Applicant : Nobuo Imamura et al.  
Serial No. : 10/566,921  
Filed : January 31, 2006  
Page : 5 of 10

Attorney's Docket No.: 15682-017US1 / OSP-19442

Amendments to the Drawings:

FIG. 4

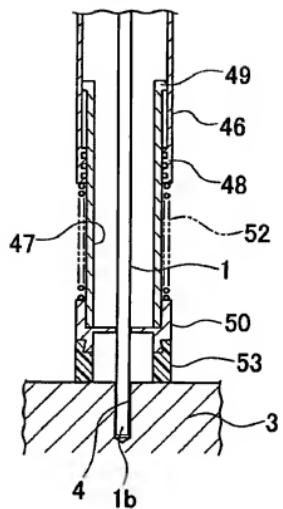
In Figure 4, the reference “62(65)” (two occurrences) has been changed to “62” and “65.”

The Examiner objected to the drawings because of the reference “62(65)” in FIG. 4. Without conceding that the Examiner’s interpretation of reference “62(65)” is correct, applicants have modified FIG. 4 to remove the reference “62(65).” FIG 4 now includes separate reference numbers “62” and “65”. A replacement sheet and an annotated sheet showing the changes to FIG. 4 are attached.

The attached replacement sheet of drawings includes changes to Fig. 4 and replaces the original sheet including Fig. 3 & 4.
